SCHWEIZER SERVICE BULLETIN

SUBJECT: TRIPLE-LATCH DOOR - LOWER LATCH BOLT AND COLLECTIVE FRICTION GUIDE ASSEMBLY INTERFERENCE

MODELS AFFECTED: All Model 269C Helicopters equipped with SA-269K-060 triple-latch door kit purchased prior to the issue date of this Service Bulletin or factory installed triple-latch doors prior to serial number 1583.

Figure B-250-1. Lower left latch bolt installation

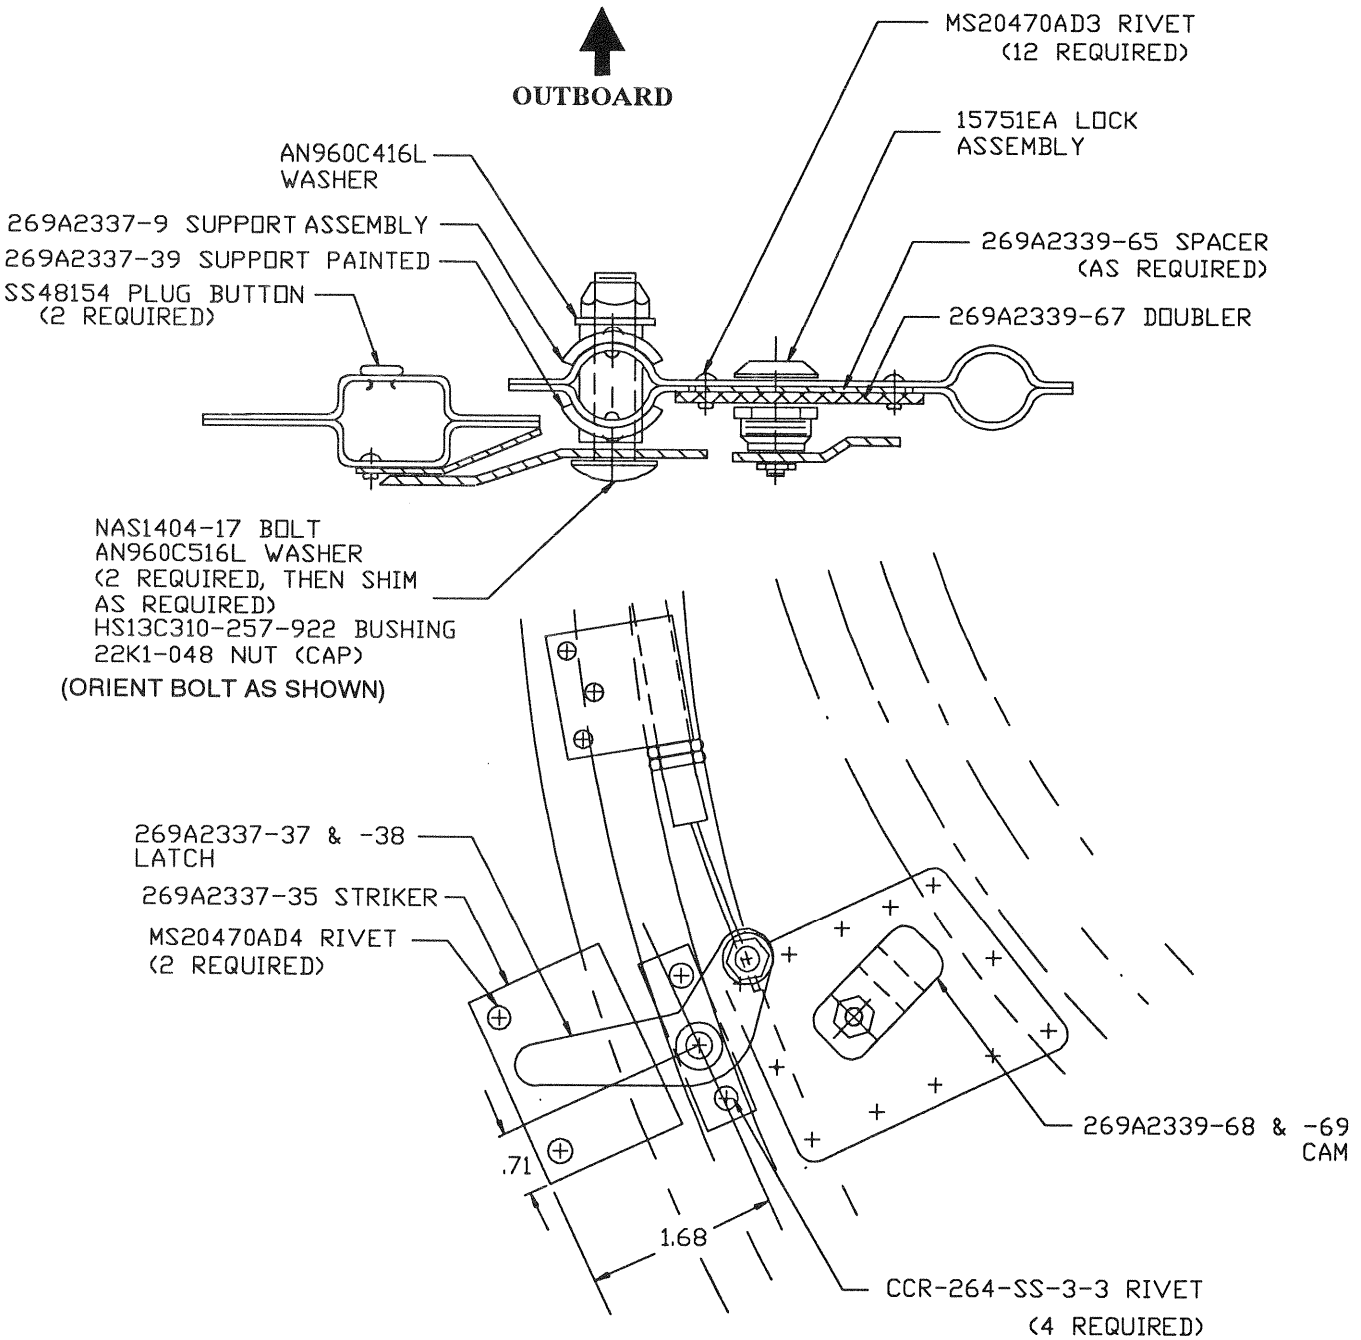
PREFACE: Reports indicate that when the left side triple-latch door is installed the lower latch nut could interfere with the collective friction guide assembly, and restrict the movement of the collective stick.

This bulletin provides instructions to reposition the lower left side door latch nut.

Refer to Figure B-250-1 for steps a. through c.

- a. Remove the 22K1-048 cap nut and washer from left side door's lower latch assembly.
- b. While maintaining proper shim stack-up remove NAS1404-17 bolt and reverse its direction by installing bolt from the inside.
- c. Install washer and tighten cap nut (now located on outside of door assembly).
- d. Close and latch door. Move the collective stick through full range (up and down) to verify adequate clearance exists between collective friction guide assembly and lower latch nut/bolt.
- e. Record compliance with this Service Bulletin in the aircraft records.
